UNITARY PLAN UPDATE REQUEST MEMORANDUM

SUBJECT Alteration of Designation 6769 State highway (Ara Tūhono - Pūhoi to Wellsford Road of National Significance: Pūhoi to Warkworth Section) of the Auckland Unitary Plan(AUP) Operative in part (15 November 2016) in accordance with section 181(3) of the Resource Management Act

Notice of requirement for a minor alteration to a designation under section 181(3) of the Resource Management Act 1991

Designation number:	Designation 6769 State highway (Ara Tūhono - Pūhoi to Wellsford Road of National Significance: Pūhoi to Warkworth Section)
Requiring authority:	New Zealand Transport Agency (NZTA)
Site address:	Wyllie Road Warkworth

Figure 2 Wyllie Road Realignment

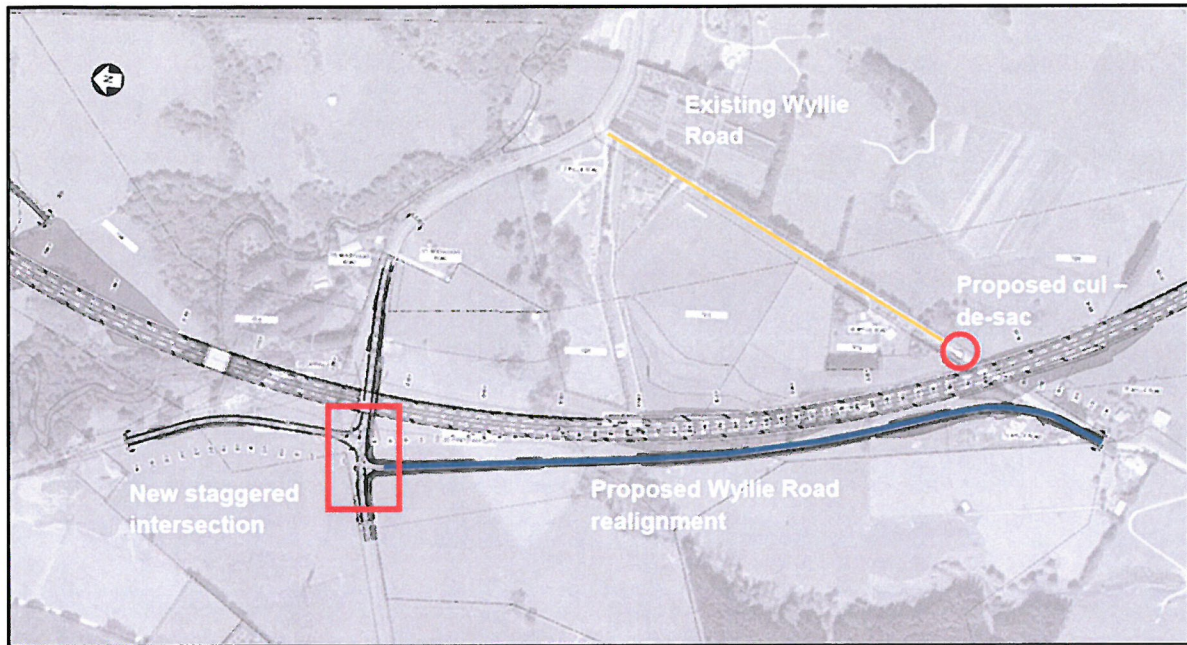
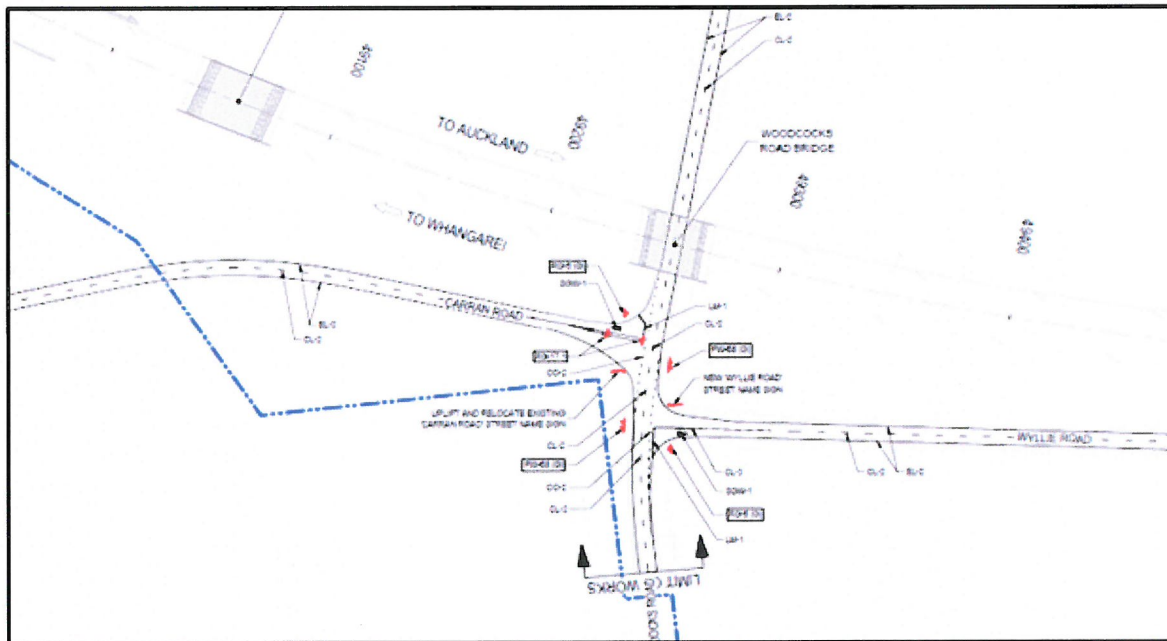
The proposed changes to the motorway alignment and to Wyllie Road are shown in more detail in Figures 2 and 3. It is proposed to realign Wyllie Road to run north parallel to the motorway and connect with Woodcocks Road west of the designation alignment at a new T

The implications of this realignment include:

- A lower vertical alignment of the motorway with no connection of Wyllie Road underneath;
- The severed eastern section of Wyllie Road (east of the motorway alignment) will end at a new cul-de-sac within close proximity to the motorway alignment;

Figure 4 Woodcocks Road bridge cross section

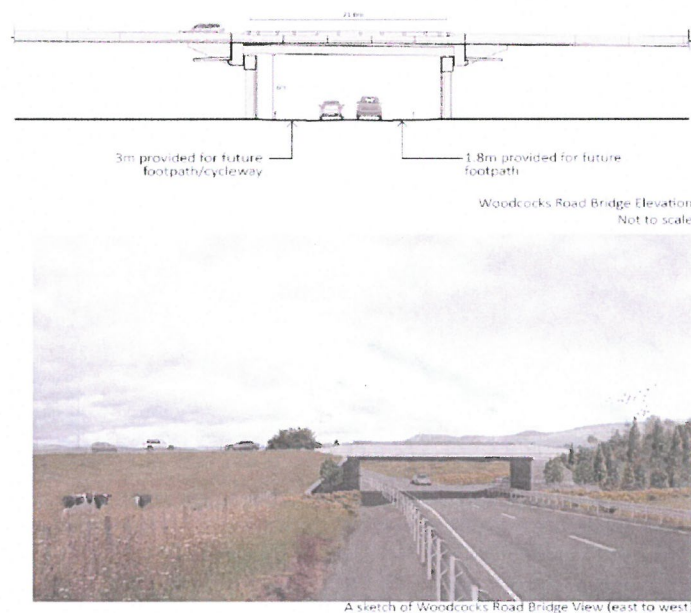
The review and staff comments also refer to the Rodney Local Board Greenways Plan which sets out routes that aim to “provide cycle and walking connections which are safe and pleasant”. One such existing route is along Wyllie Road. The review states:

1. *Include the provision of pedestrian and cycle facilities along the re-aligned section of Wyllie Road and under the motorway in accordance with the Rodney Local Board Greenways Plan.*

The requiring authority does not agree with the proposed amendments. It considers that the proposed design does not preclude the construction of a footpath or cycle path as sufficient width is provided within the local road. The figure presented by the applicant (see Figure 4 below) shows what it considers to be sufficient space underneath the Woodcocks Road bridge to provide for future pedestrian/cycle paths along Woodcocks Road. It also notes that the design has been subject of a safety audit which includes consideration of cyclists and pedestrian use.

This response has been reviewed by the council's transport expert and he suggested that the condition be amended to future proof the condition as AT is developing a new Transport Design Manual which will replace the code of practice, by the addition of the words:
